stuart buzzard point | washington, dc

april 8th, 2026 | L01

SK+I | Stuart Investment Company | MRP Realty | FRP | OCULUS

proposed phase 1: 1st floor plan

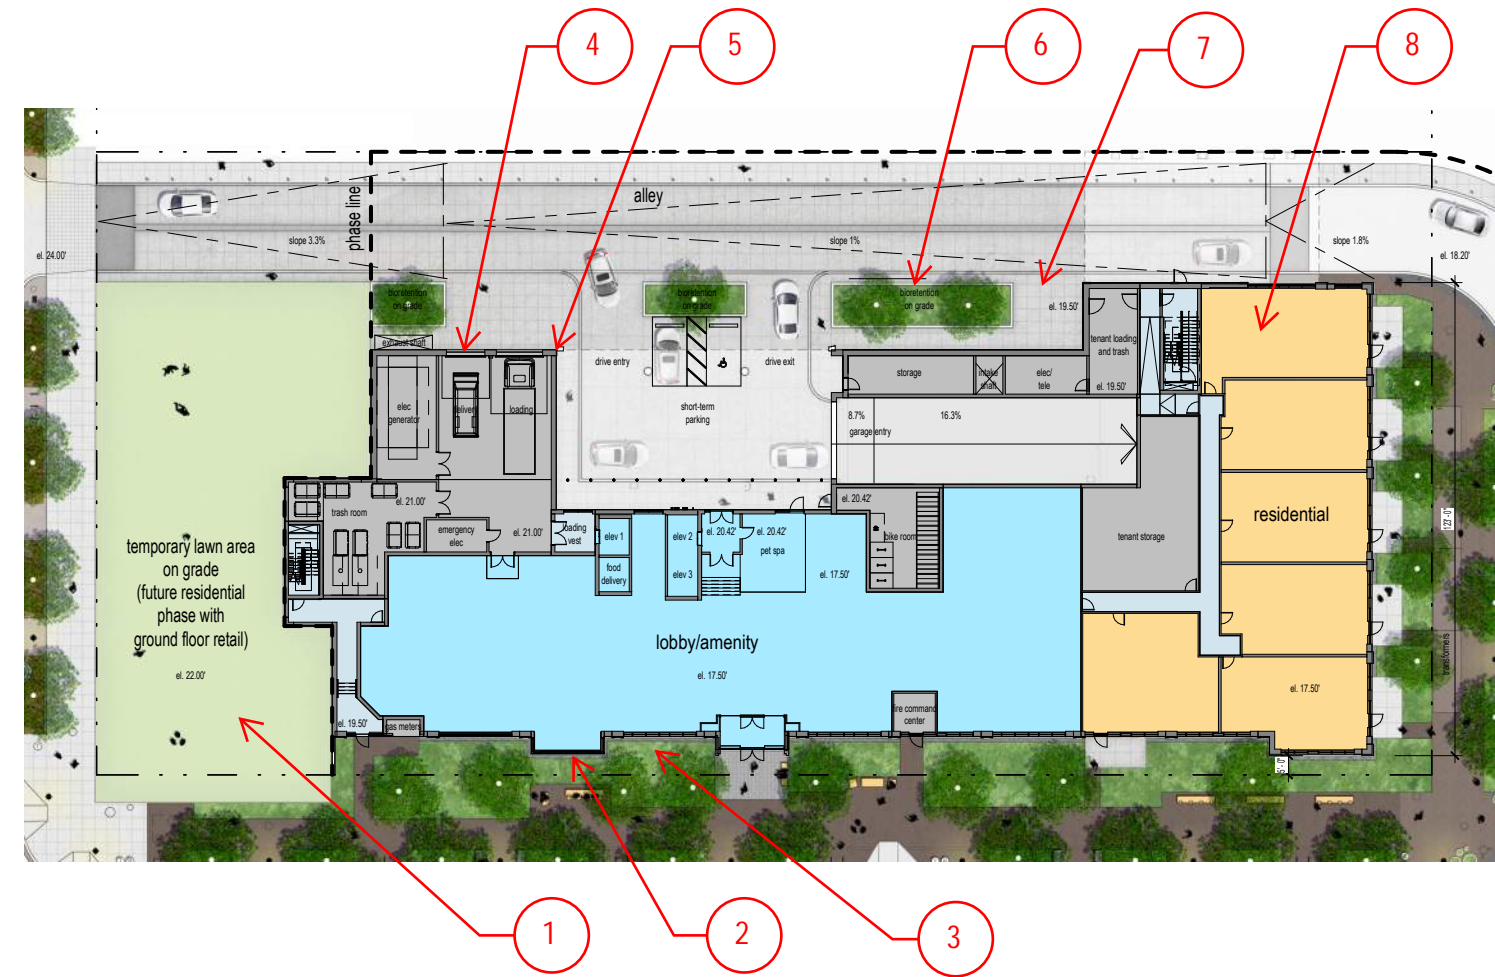
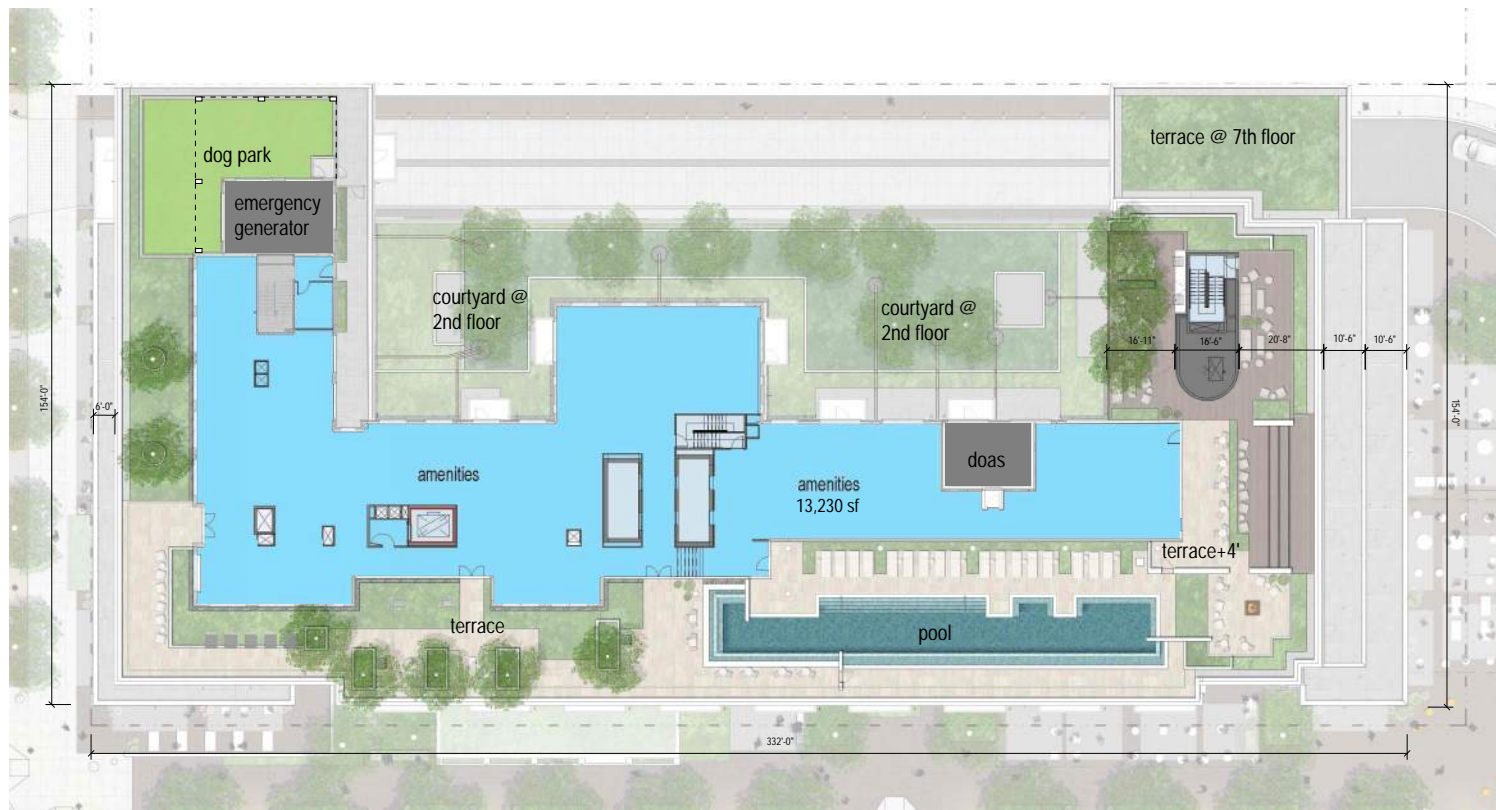
1. for feasibility purposes, re-phasing of building development removes west wing as part of phase 1 and replaces the footprint of the west wing with temporary lawn space until the future residential phase is constructed with ground floor retail. phase 1 unit count is reduced from 452 to approximately 335.

2. bay window has shifted east in coordination with amenity space inside.
3. canopy and amenity indoor/outdoor space have been removed and replaced with green space.

4. loading, delivery, and electrical generator have been relocated in coordination with new phasing.
5. exterior facade at dropoff has been pushed back to provide light and breathing room to the alley, as well as daylight and visibility to the dropoff.

6. bioretention has been added on grade along the alley, providing more greenery to soften alley.
7. additional short-term parking/loading space has been located near east wing back of house.

8. residential loft units with individual direct street entrance added to promote better streetscape engagement and ensure activation in light of ongoing retail market challenges.

proposed phase 1: penthouse floor plan

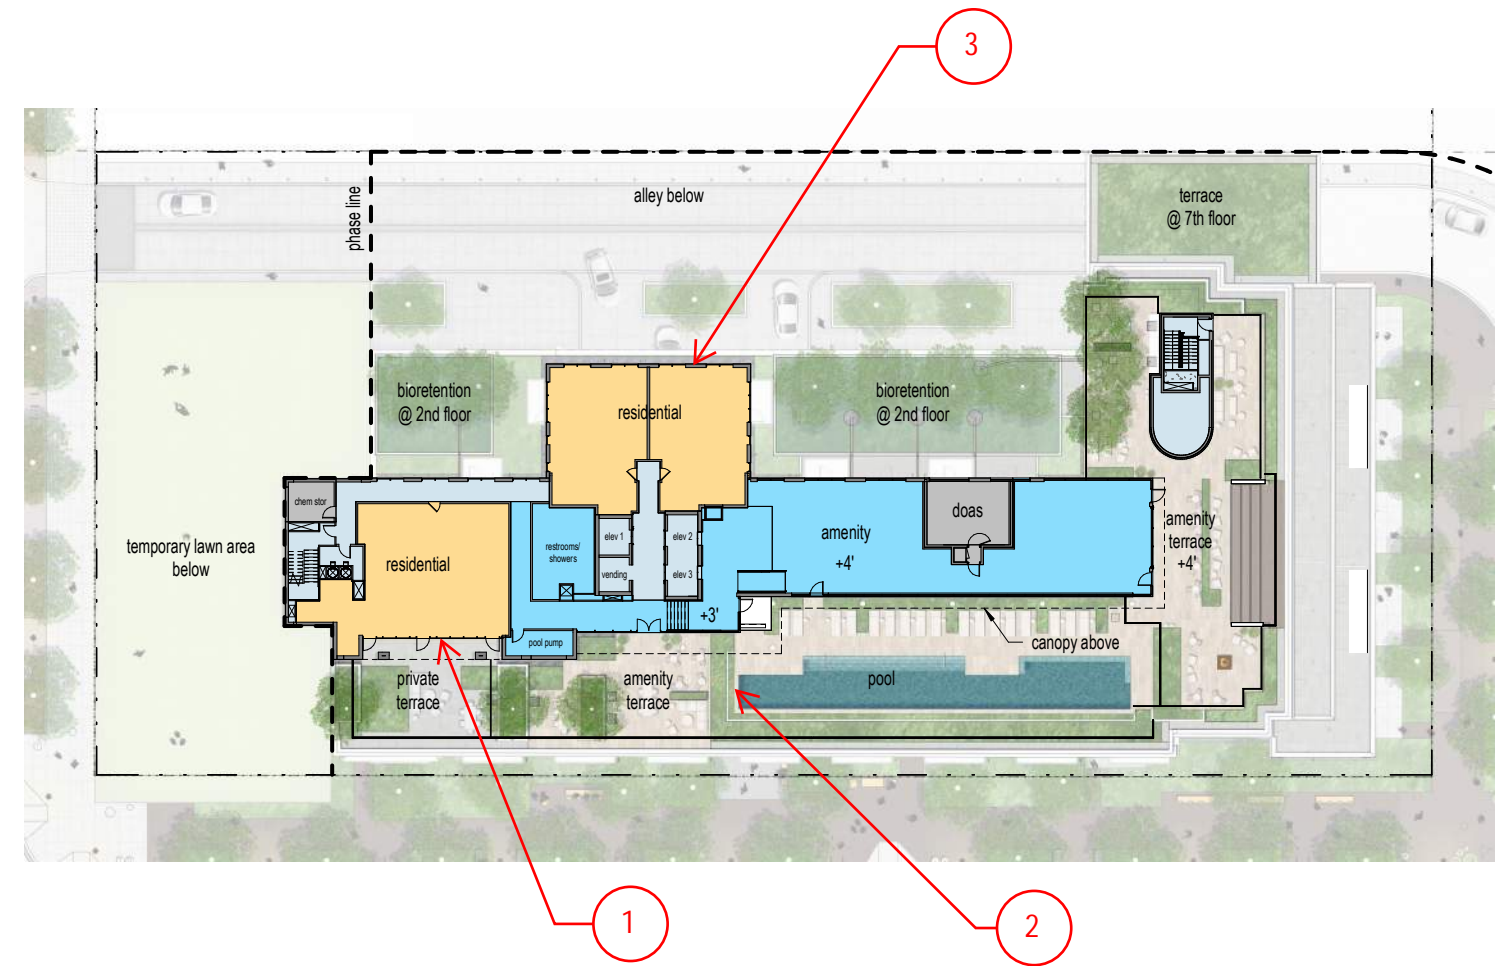
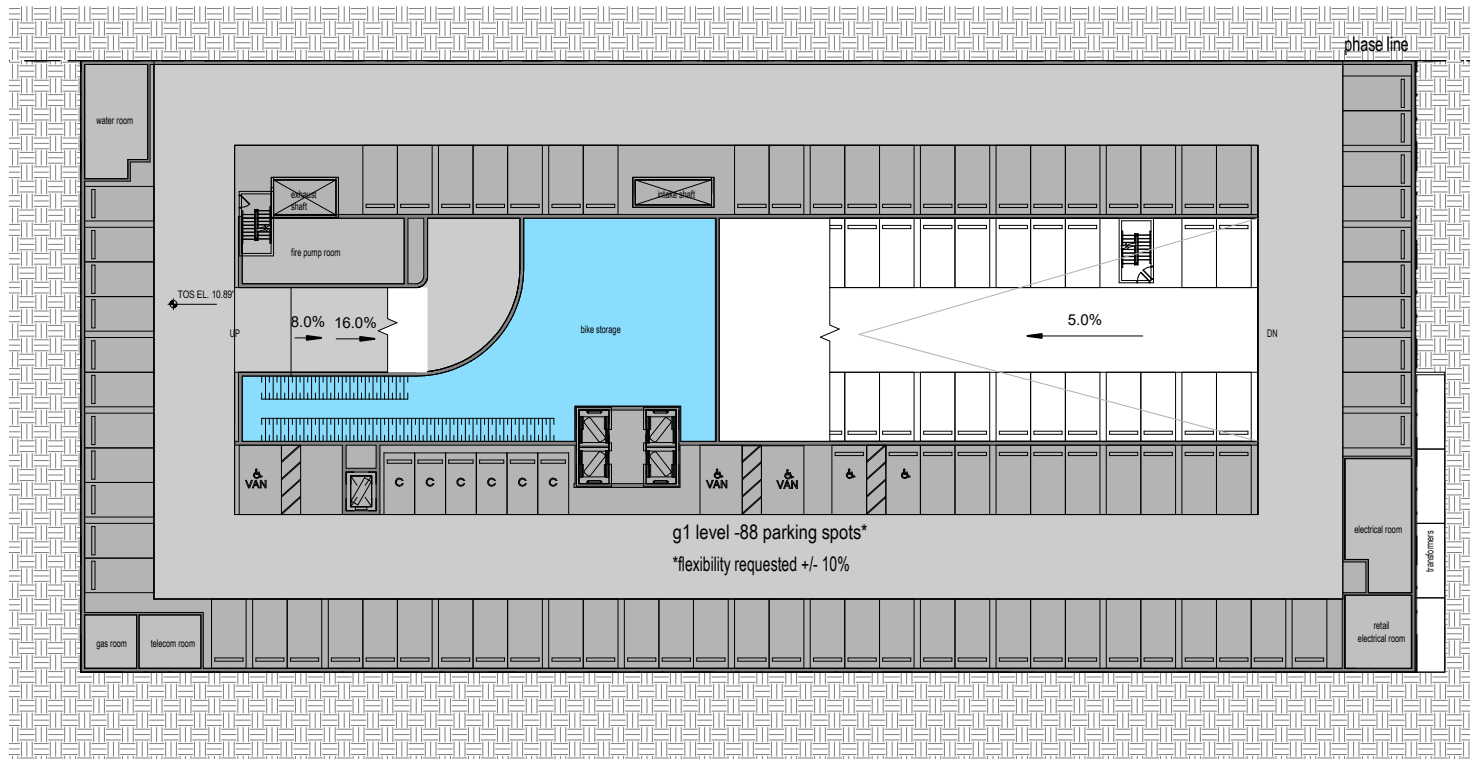
1. unit and private terrace have been added at west end of new phase 1 building in place of amenities, which were relocated to the 1st floor to provide street activation.
2. pool deck has been shortened and shifted to align with penthouse building face and entrance to pool deck, giving more space to the year-round amenity terrace adjacent to the elevators.
3. units have been added north of the elevators in place of amenities, which were relocated to the 1st floor.

proposed phase 1: g1 level plan

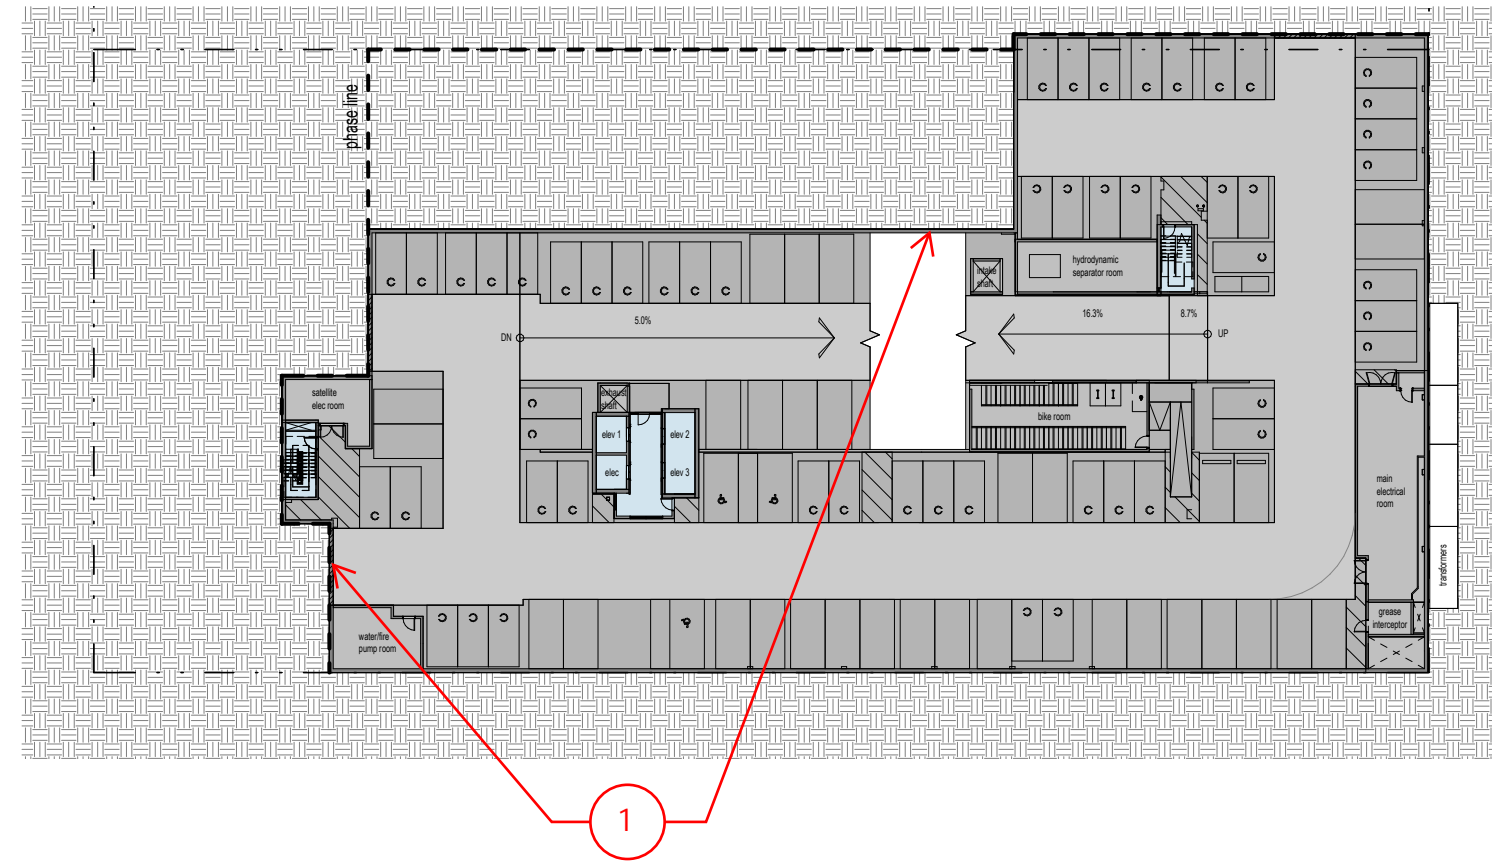
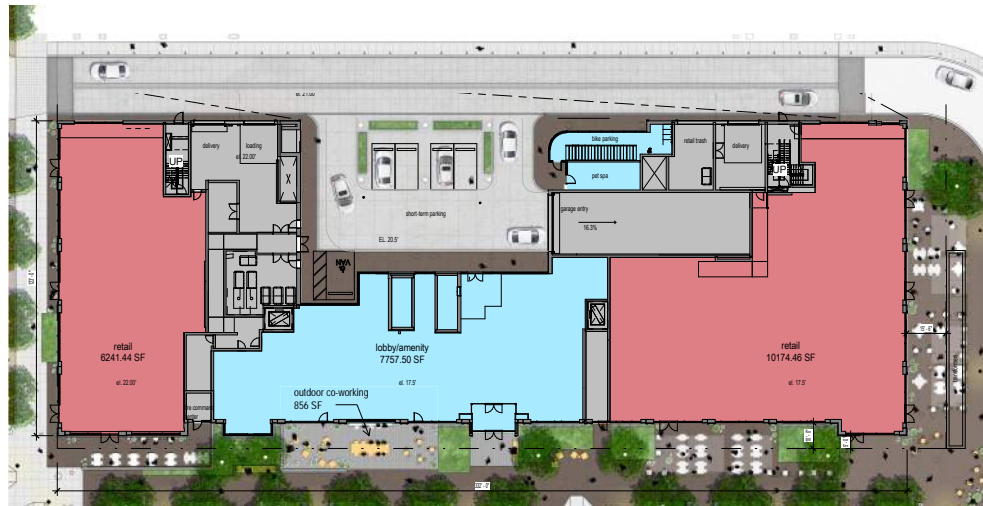
1. garage footprint has been reduced in coordination with new phase line of building. total number of parking spaces has been reduced from 264 to 196 in response to reduced number of units and removal of retail as part of phase 1.

proposed phase 1: north elevation

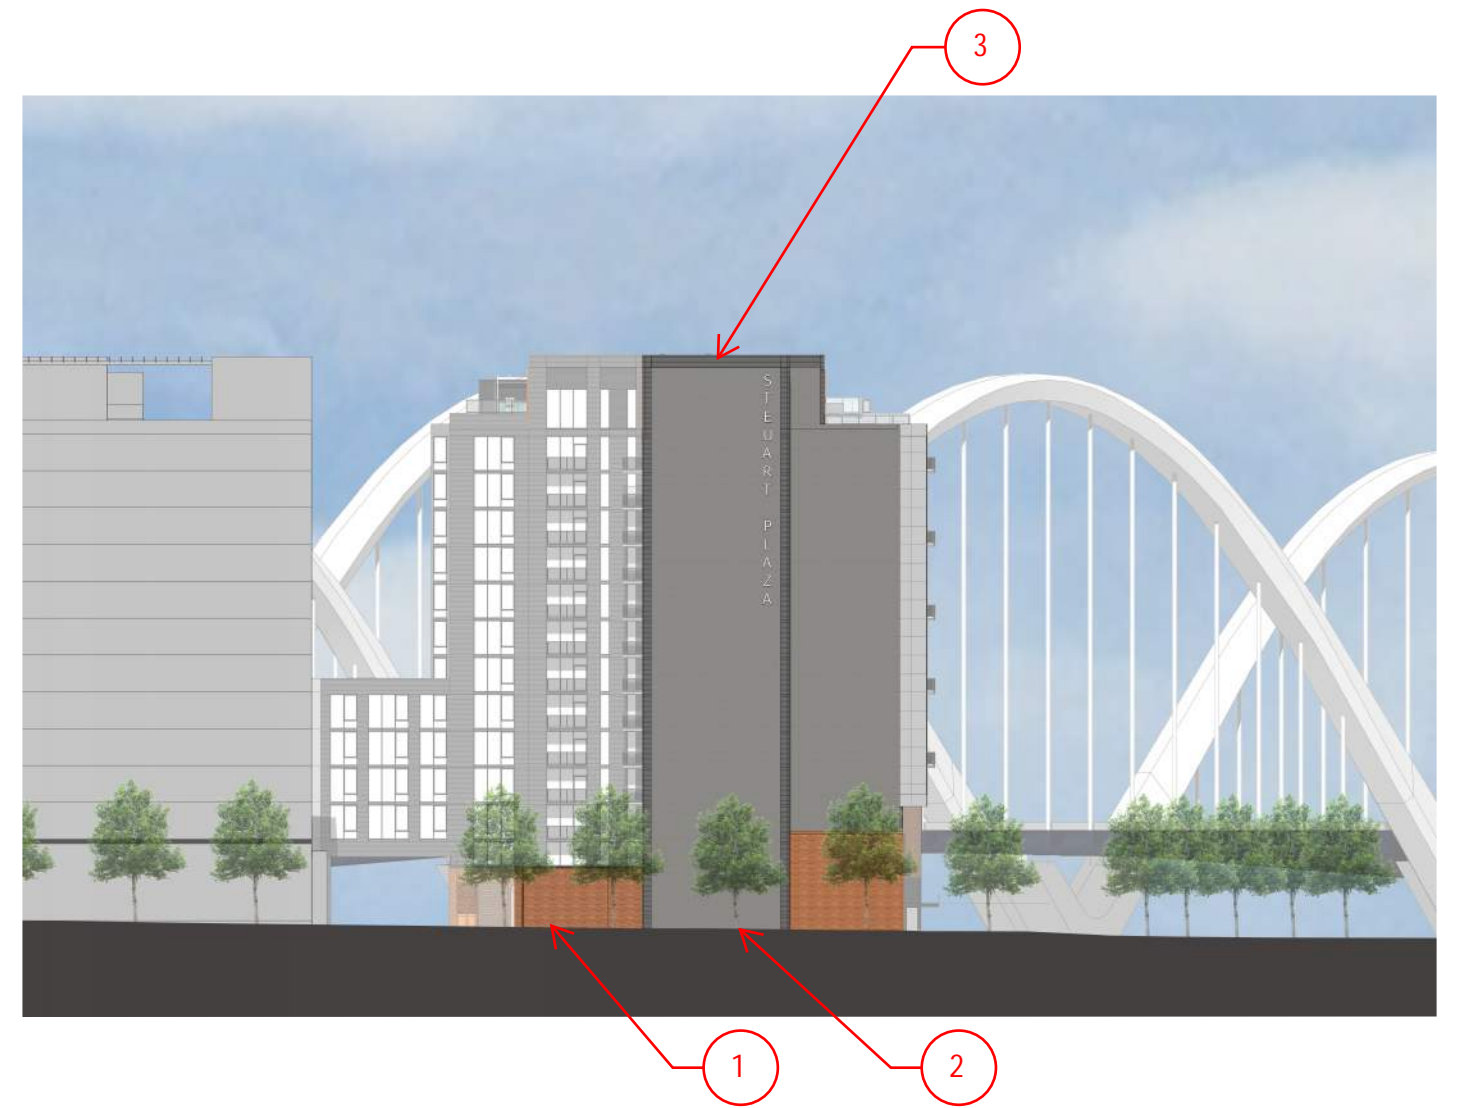
1. additional short-term parking/loading space has been located near east wing back of house.
2. bioretention has been added on grade along the alley, providing more greenery to soften the alley.
3. exterior facade at dropoff has been pushed back to give some light and breathing room to the alley, as well as daylight and visibility to the dropoff.
4. loading, delivery, and electrical generator have been relocated in coordination with new phasing.
5. rephasing of building development removes west wing as part of phase 1 and replaces the footprint of the west wing with temporary lawn space until the future residential phase is constructed with ground floor retail.
6. west end of north facade is similar to previously approved facades where future phase connections will be made with metal panel trim surrounding EIFS on CMU with space for building signage.
